Docket No. 50-440

SUBJECT: TRANSMITTAL OF TECHNICAL SPECIFICATION CHANGES FOR PERRY NUCLEAR  
POWER PLANT, UNIT 1

Perry Nuclear Power Plant  
Units 1 and 2

FIGURE 6.2.2-1  
UNIT ORGANIZATION

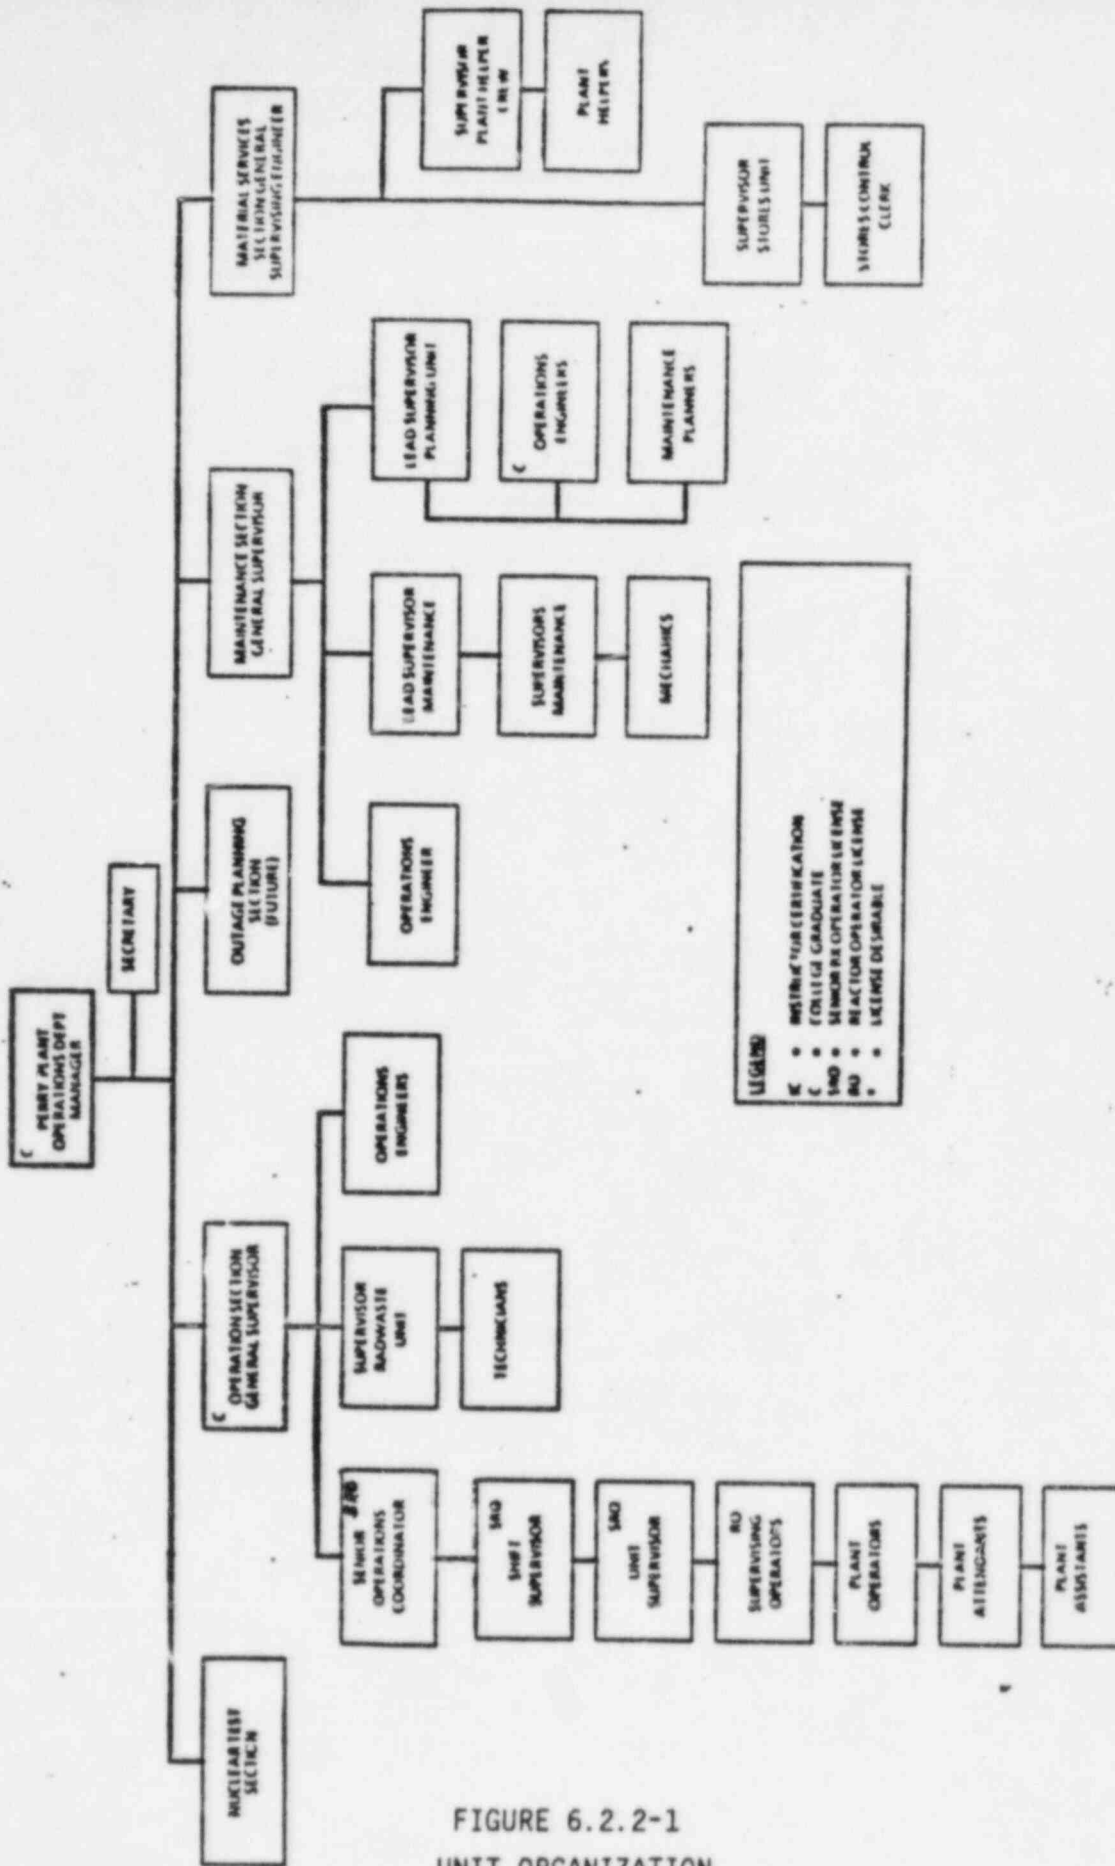
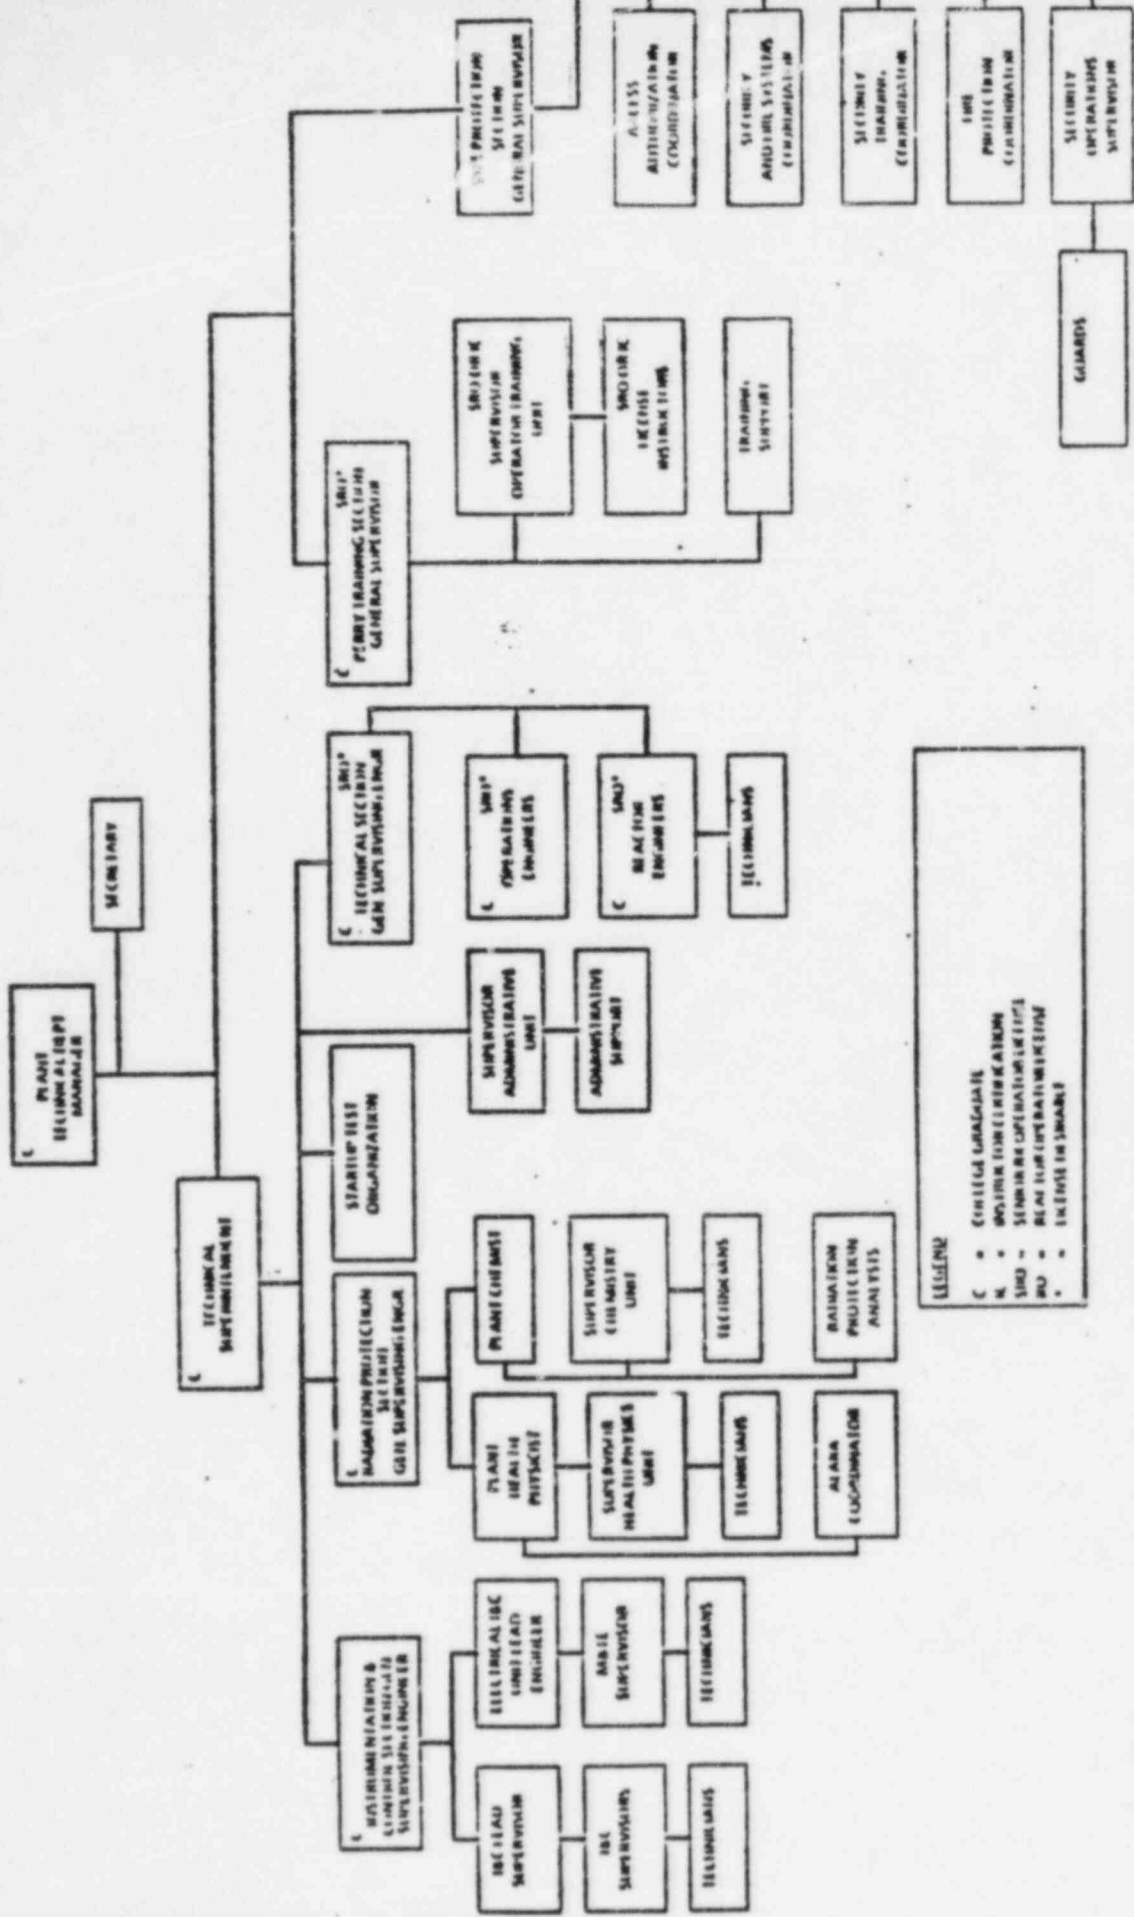
B. J. Youngblood's letter to you dated November 19, 1985 transmitted for your certification the final draft of the Perry Unit 1 Technical Specifications. However, since that letter was issued, we have received additional staff comments which correct several editorial and typographical errors. These changes are reflected in the enclosed Technical Specification pages, which have been discussed with your representatives.
